RESIDENTIAL BUILDING PERMIT APPLICATION

MEMORANDUM

RE: *1021 High Stepper Trail*, Potential Basement Bedroom

1
A-6 **BASEMENT FLOOR PLAN**
SCALE: 1/4" = 1'-0"

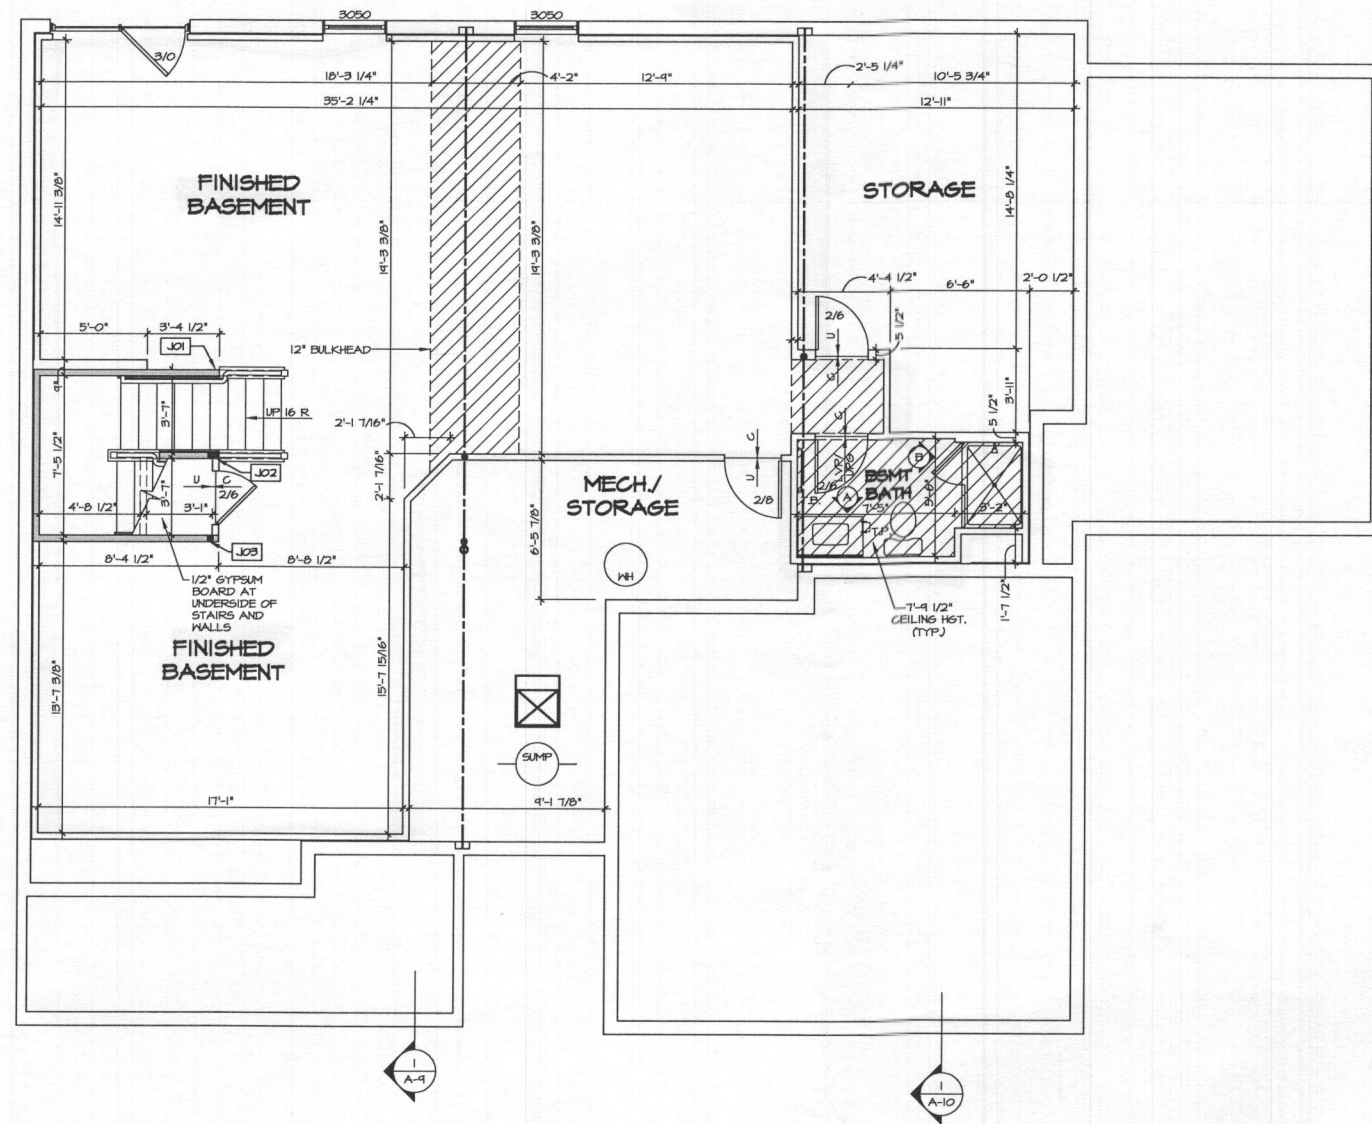
I have reviewed the floor plans in support of Building Permit **B20001260** for a new home at **1021 High Stepper Trail** and noted that there is a full bathroom planned in the partly-finished basement. Please note that this makes it very likely for at least one more room to be considered a bedroom should the basement layout be modified and/or an egress window installed.

The Health Department strongly recommends sizing the onsite sewage disposal system at least one bedroom larger than the existing **four (4)**- bedroom design to accommodate a future modification of the finished basement. If you choose to only size for the existing design, any future building permit for modification of the finished basement may be placed on hold until the system is upgraded to accommodate the proposed number of bedrooms. This memo will be retained in the Health Department file for future reference.

Finished area lacking privacy

SECOND FLOOR PLAN
SCALE: 1/4" = 1'-0"

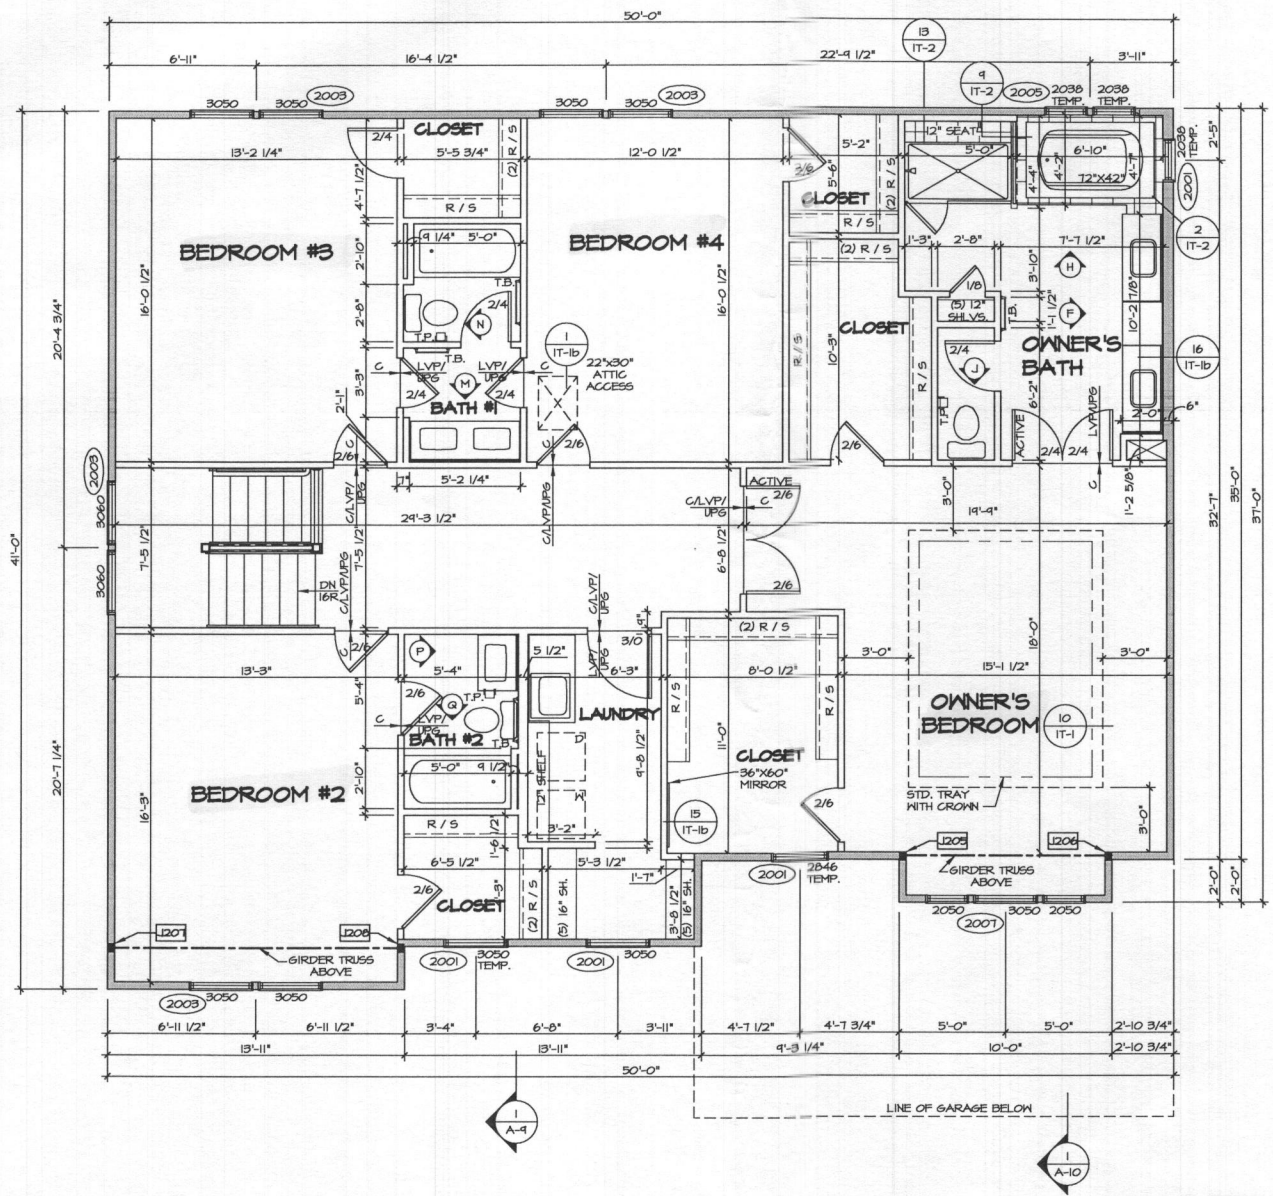
*4 Bedrooms
'OK' req*
